5.2. Traffic and Transport issues

5.3. Built form

Figure 11: Location of Intersection Upgrade works

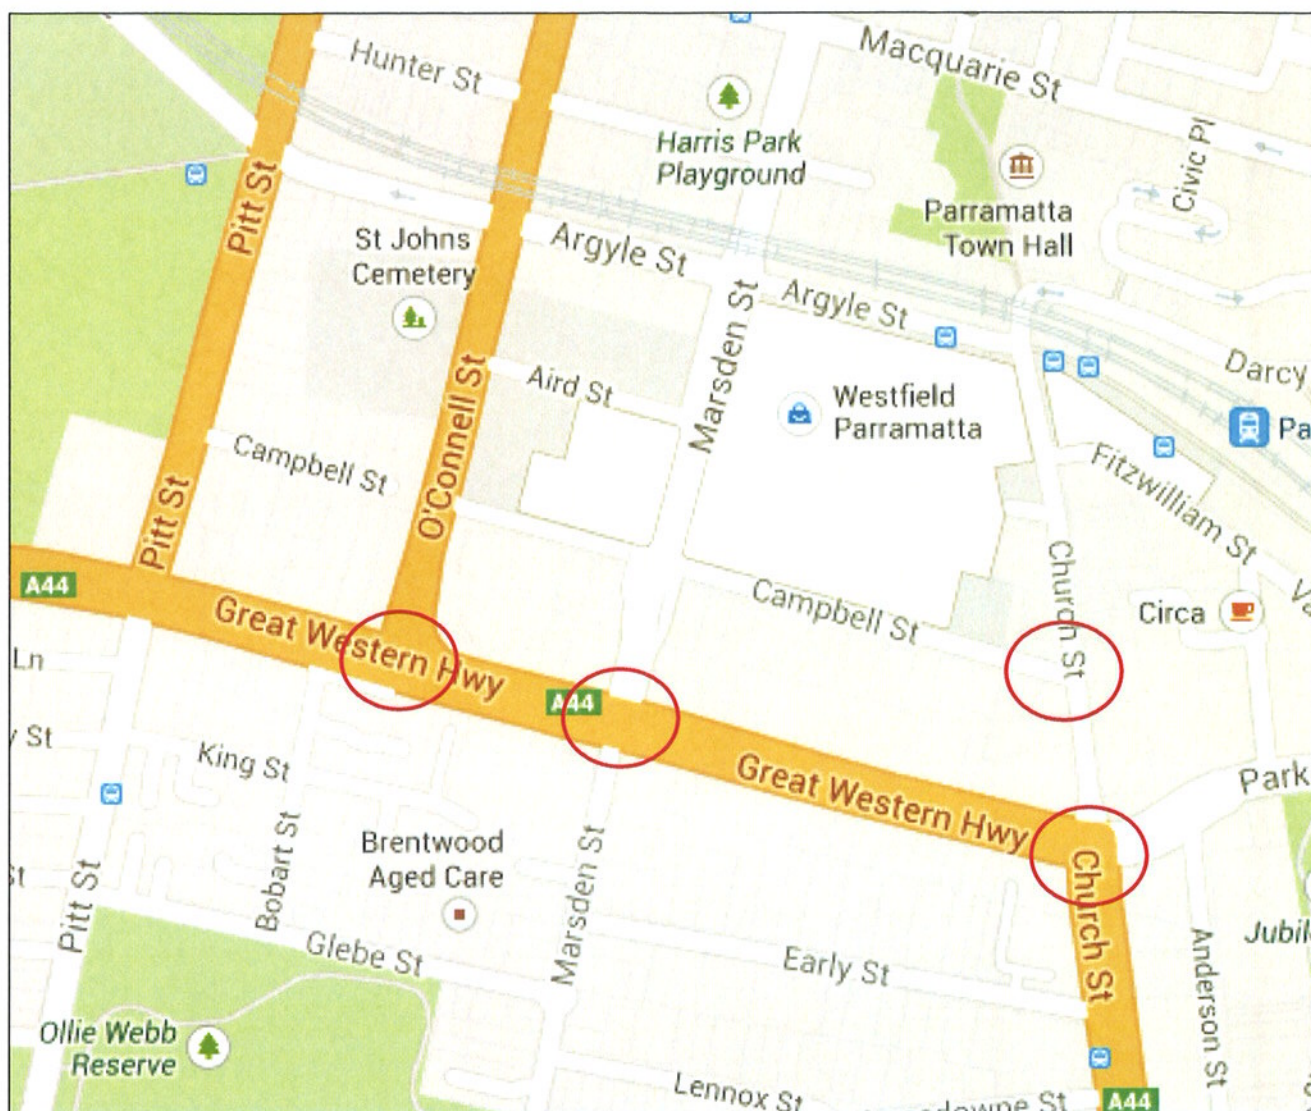
The modelling submitted with the PPR demonstrated that the proposed development would result in significant further deterioration of the surrounding road network. However, with the upgrade of the 4 intersections above, overall traffic flows in the area would be improved. The results of the modelling for the PM peak (the worst affected time of day) are shown in **Table 6**.

As a result of the findings of the modelling submitted with the PPR, the RMS and Council initially suggested that the proponent should be responsible for the provision of all four intersection upgrades to mitigate the adverse traffic impacts of the proposal.

The proponent raised a number of concerns with this approach, and in particular with the provision of the intersection upgrade at Great Western Highway / Church Street / Parkes Street. This intersection required significant land acquisition for road widening which the proponent did not have the authority to acquire and in addition, construction costs were estimated by the proponent to be around \$1.5 million which they considered an unreasonable financial burden. The proponent did, however, agree to funding the remaining two intersection upgrades on The Great Western Highway which they estimated to cost \$80,000 in total as well as the Campbell Street upgrades which have not been costed.

However, as the Great Western Highway and its associated intersections are State Government assets under the control of the RMS, the Department accepts the RMS's position that only the Marsden Street / Great Western Highway intersection upgrade is necessary in this case, as the RMS will seek other necessary intersection upgrades through alternative means.

The Department also agrees with the RMS that the Marsden Street / Great Western Highway intersection remains essential in order to mitigate the adverse traffic impacts of the proposal as demonstrated by the modelling. As such, conditions are recommended requiring the provision of the intersection upgrade prior to occupation of Stage 1. Conditions are also recommended requiring the upgrade at Campbell Street upgrades as was always intended by the proponent.

Figure 13: Proposed building envelope showing encroachment of DCP street frontage building height controls (Source: Proponent's Environmental Assessment)

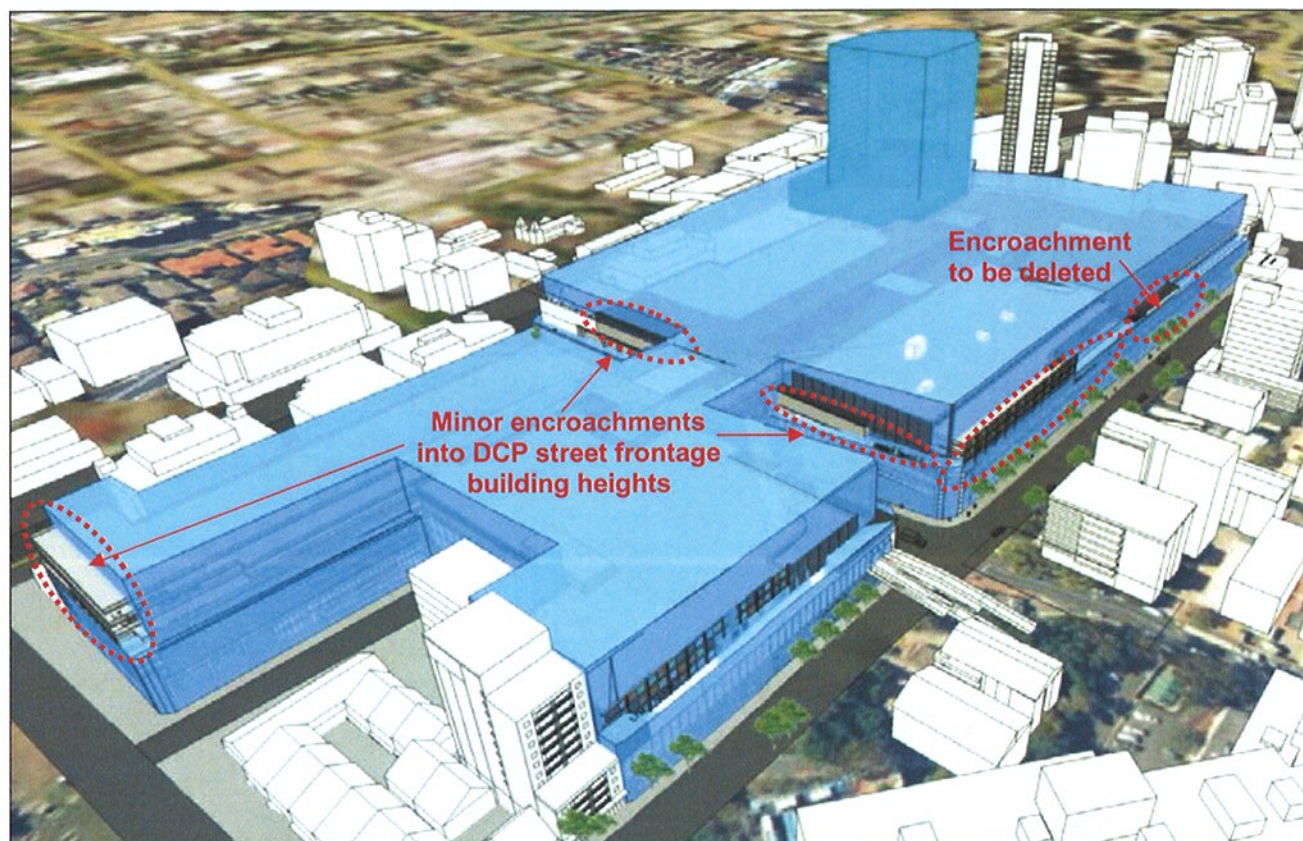
Street and boundary setbacks of the proposed additions are also generally consistent with controls set out in the DCP, with some minor encroachments at upper levels along Campbell Street, Marsden Street and O'Connell street as depicted in **Figure 13**. It is noted that the DCP controls, such as the street setbacks, are not given any weight under the former Part 3A provisions and were not listed in the DGRs as a policy or guideline to be addressed. As such they do not strictly apply to the assessment of the application. Further, since the PPR submission, the proponent has suggested setting back part of the additions further from the street to address overshadowing of a heritage item (refer to discussion in **Section 5.4.2**) so that the extent of encroachments is further reduced (refer **Figure 13**). The remaining encroachments do not result in any significant shadow impacts to nearby

residential properties, and with the provision of further façade design and material details as discussed below, no adverse visual impacts are considered to arise from the minor encroachments.

On this basis, the bulk and scale of the proposed retail additions is considered to be acceptable.

Figure 17: Proposed new ground floor openings to Argyle Street (source: Proponent's EA)

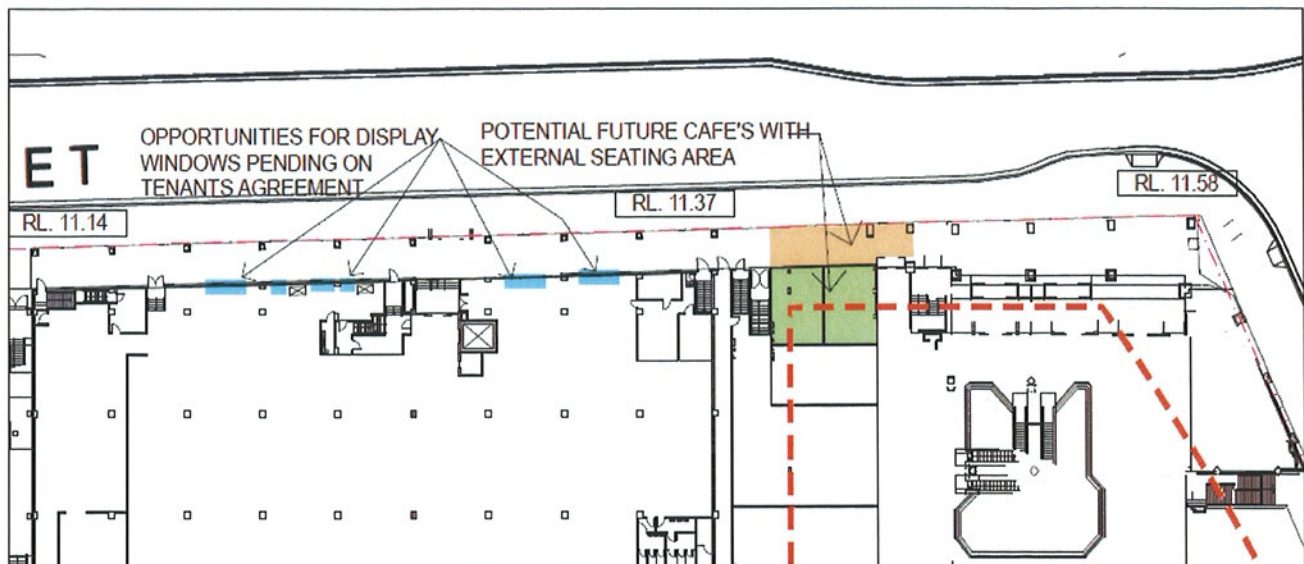
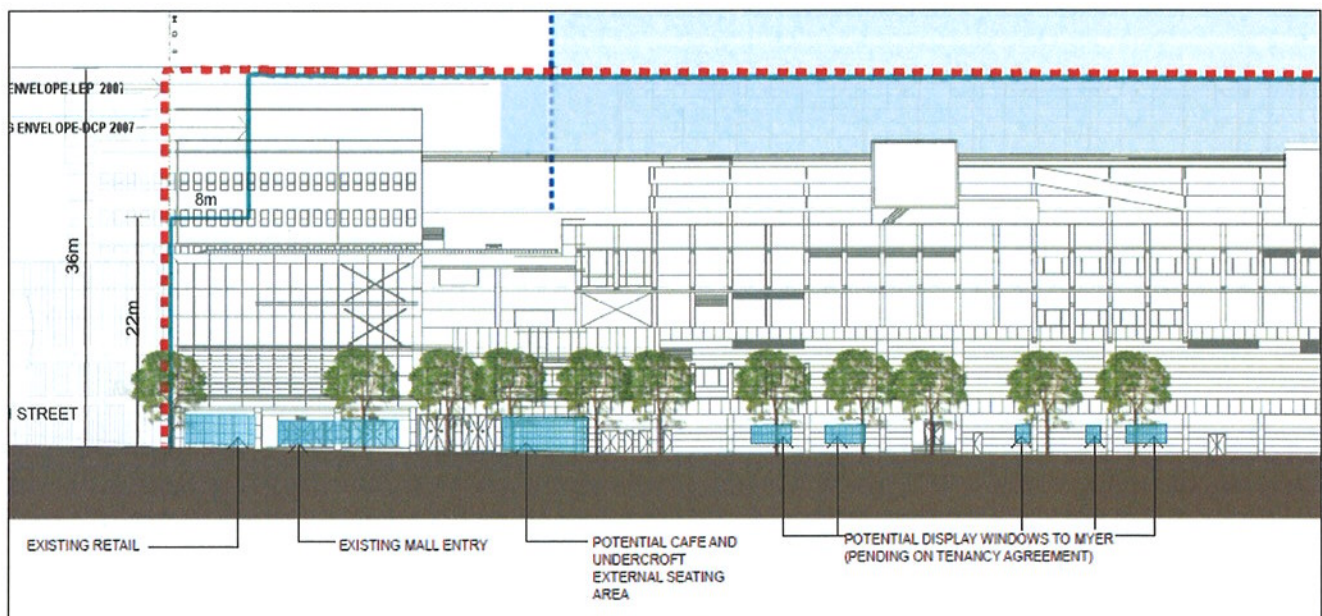
However, the proponent has agreed to make some improvements in terms of street activation. The main improvement would be to the Argyle Street façade adjacent to the bus interchange and would include new openings to a potential future café and new department store window display windows (refer **Figures 17 and 18**). The proponent originally advised that these changes could only be provided at Stage 2 and would be subject to the tenant's agreement, but subsequently advised that although not preferable, the changes could be brought forward to within 24 months of completion of the Stage 1 works.

A condition is therefore recommended that the works to Argyle Street depicted in **Figures 17 and 18** above are provided as part of Stage 1, and that amended plans be submitted and approved by the Director-General incorporating activation of the entire Church Street façade at the footpath level and any necessary redesign of existing adjoining services and fire escapes.

Figure 19: Existing inactive façades to Church Street retained (source: "Street Activation Concept Floor Plan" in Proponent's PPR)

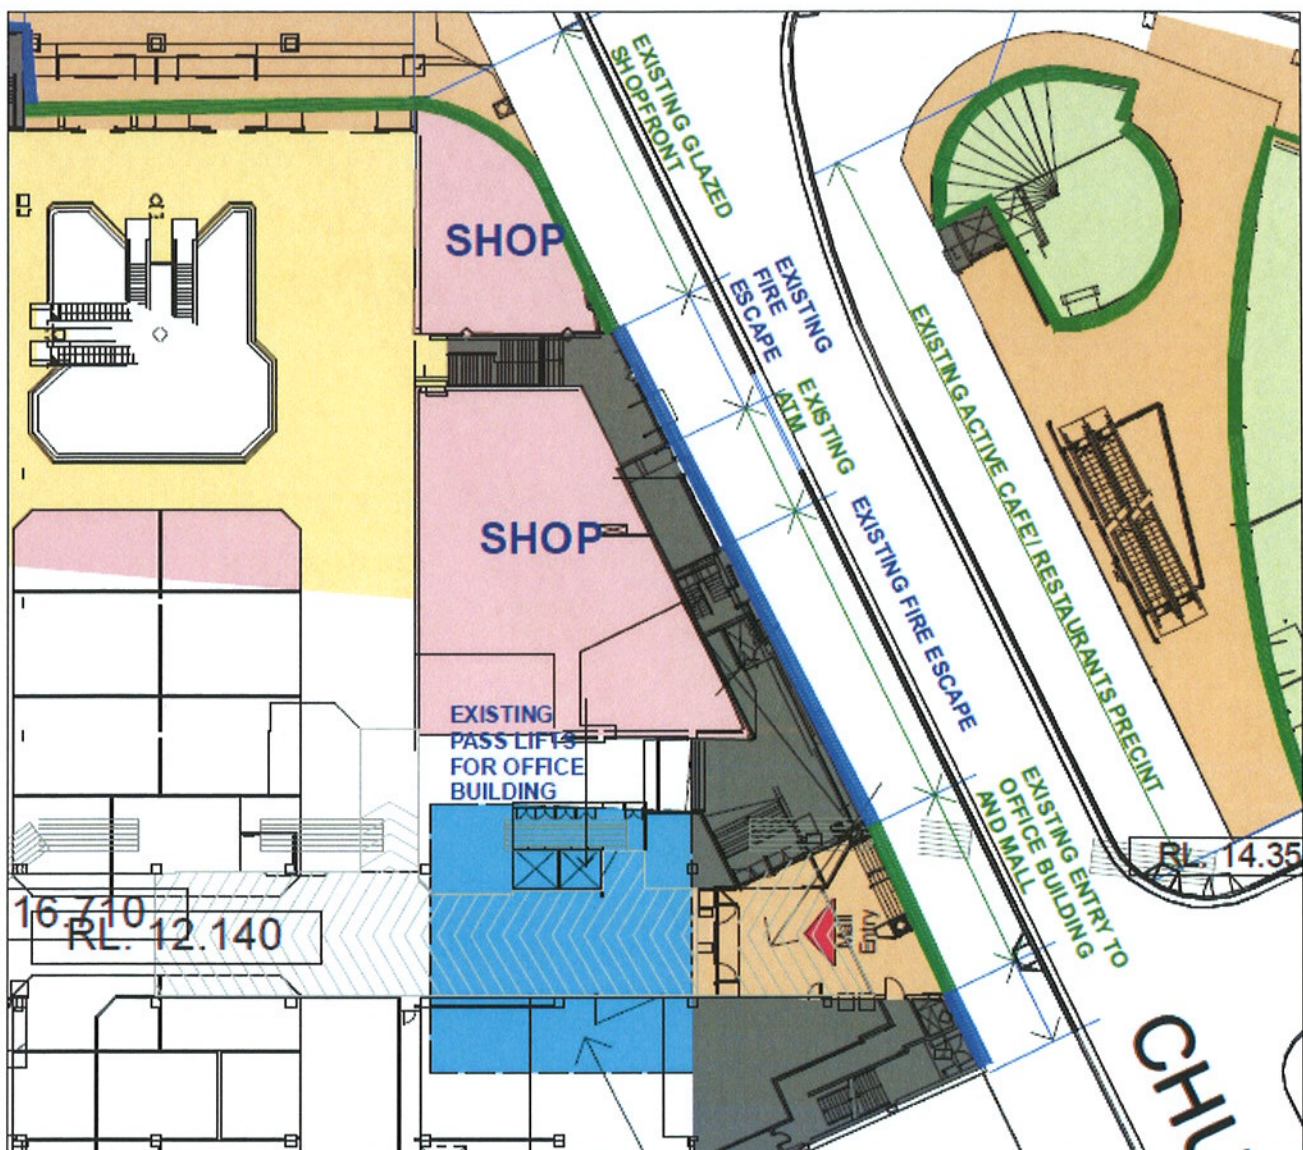
No changes are proposed to the Church Street façade and it is proposed to retain the existing inactive frontages (refer **Figure 19**). The proponent has, however, advised that there may be upgrades to this facade as part of Stage 2 in order to facilitate the integration of the future office design and façade of the retail podium, although it is noted that the plans submitted with the Concept Plan application do not accommodate for any changes at the retail podium in this regard.

The proponent argues that the nature of such changes cannot be ascertained until the design of the tower is prepared following the design competition, and that any changes to the façade imposed now may be inconsistent with the future design or may unnecessarily constrain the design options for the tower.

It is not considered appropriate to delay the changes to Stage 2, as proposed by the proponent, as there is no timeline or guarantee that the works will ever be undertaken. Whilst it is acknowledged that the design of Stage 2 may have some impact on the layout of the retail area below it, for example, due to the insertion of future supporting columns for the office tower, these will be well setback (around 8 metres) from the facades and will not impact on actual façade design changes. Furthermore, it is considered that with good design and planning at Stage 1, it should be possible to make changes to the ground floor plan that results in active street frontages as part of Stage 1, and which also provides enough flexibility for a future floor plan to accommodate supporting columns and any other changes such as new lifts or entry lobbies associated with the tower.

Figure 20: Tower building envelope (Source: Proponent's Environmental Assessment)

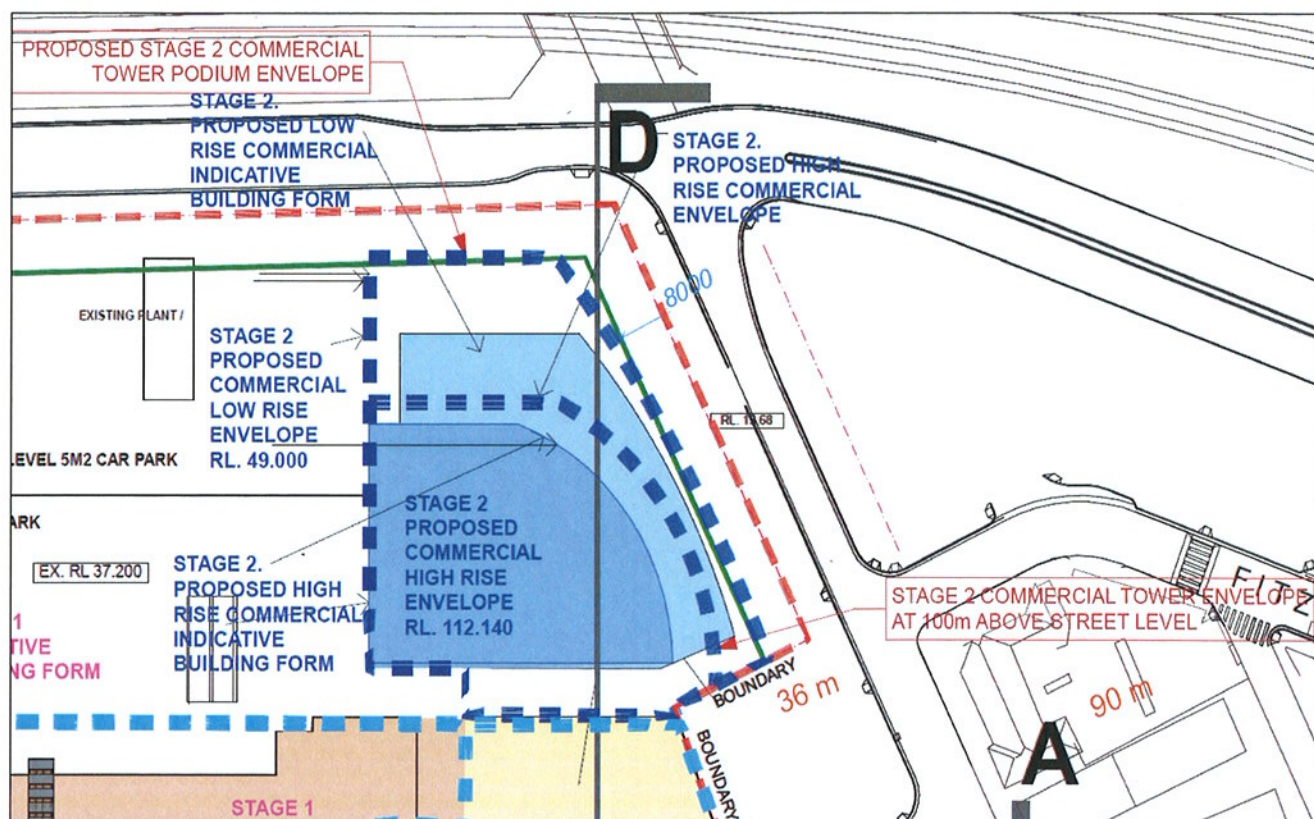
Council has advised that while it supports a commercial tower in this location, it has concerns about the form and scale of the proposed tower. Specifically, it submits that the proposed floor plate is excessive and will lead to an inappropriate urban form at a future stage. Based on the figures set out in the EA and PPR, it recommends a maximum building envelope of 1,800m² and maximum floor plate of 1,400m² to ensure an appropriate visual bulk and scale, promote sustainability and internal amenity. It also recommends that the 5-storey plinth or podium levels which create a tiered effect should be deleted in favour of a simpler tower form, and that part of the tower component should engage directly with the street without any setback and by incorporating an entrance forecourt into the design.

The Office of Environment and Heritage (OEH) also raised concerns about the bulk and scale of the proposed office tower on the basis of its visual impacts to surrounding heritage buildings. It recommends reducing the bulk and scale of the proposed commercial tower, without increasing the height to reduce the dominance of the tower on view corridors and setting of landmark heritage items in the vicinity, in particular, the State-listed St John's Cathedral, Parramatta Town Hall and Parramatta Park. Heritage issues are discussed in detail in **Section 5.5** below.

Figure 23: Comparison of proposed and Council recommended indicative buildings
(source: proponent's PPR)

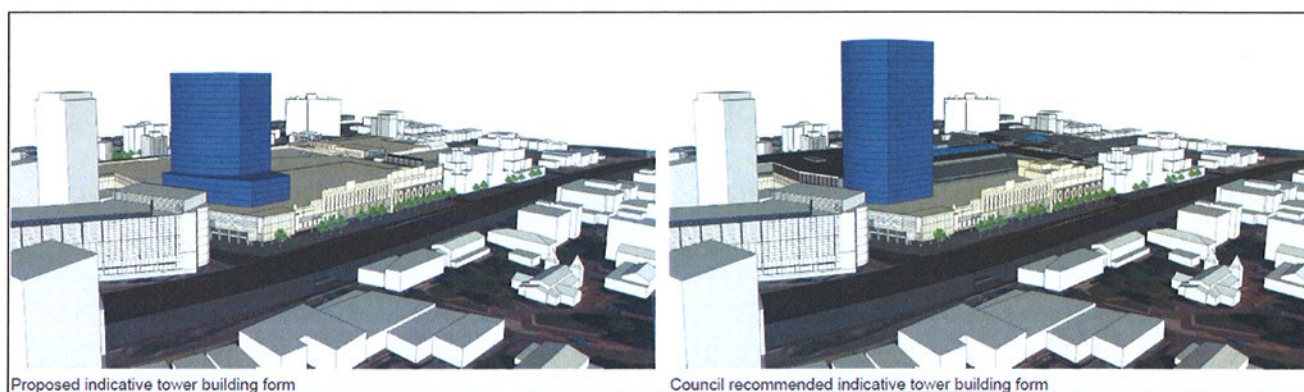
In response to concerns raised by Council and the Department in relation to floor plate size and building bulk, the proponent prepared 3D diagrams illustrating a comparison between the proposal as submitted (1,660m² building footprint) and an alternative building form with the building footprint reduced to 1,400m² and height increased to 120m (refer to **Figure 23**).

The proponent submits that the difference between the two envelopes in terms of bulk and scale is modest, and that the taller slimmer version would in fact be more noticeable as it encroaches further into the skyline. It also advises that the tower would be more noticeable from the World Heritage listed Old Government House, and this may have implications for future approval requirements under the EPBC Act, while no issues arise with the current proposal (as discussed in **Section 5.5.2** below).
